In re: Docket No. A-2021-3024267

Application of Aqua Pennsylvania Wastewater, Inc. pursuant to Sections 1102, 1329 and 507 of the Public Utility Code for Approval of its Acquisition of the Wastewater System Assets of Lower Makefield Township

**UPDATED EXHIBIT A,
REQUESTED TERRITORY MAP**

Proposed Service Territory
Lower Makefield Twp., Bucks County, Pennsylvania

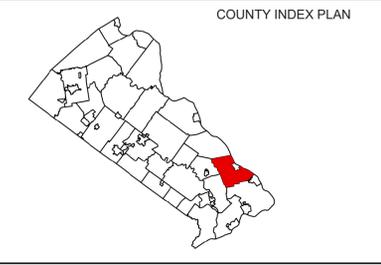
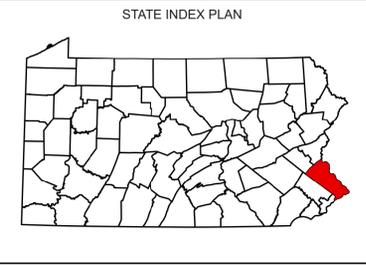
Checklist Item No. 22.a - The Application’s Exhibit P2 included Map No. 1 titled “General Plan of Sanitary Sewers with Services Area” revision dated August 17, 2018 (Services Area Plan). The Services Area Plan depicts a black hatched area in Cell M8 not defined in the sewer service area legend with an arrow indicating “Township of Falls Authority” and appears to remove this area from LMT’s service territory. Please provide a copy the DEP- approved Sewage Facilities Planning Module(s) or other DEP-approved documents specifically addressing this area and assigning the responsibility for sewerage to the Township of Falls Authority. Also, if the black hatched area was removed from LMT’s service territory, please amend the Application’s Exhibit A to conform with LMT’s DEP- approved sewage planning area.

The black hatched area identifies parcels that are split by the boundary between LMT and Falls Township. The property buildings are located in Falls Township and the Township of Falls Authority provides sewer service to those properties. An updated Exhibit A, Requested Territory Map, is included with this letter to exclude those parcels.

REV.	DATE	DESCRIPTION
6.		
5.		
4.		
3.		
2.		
1.	6/9/21	Excluded parcels served by Falls Township (black hatched area on General Plan of Sewers, LMT, 8/31/18)
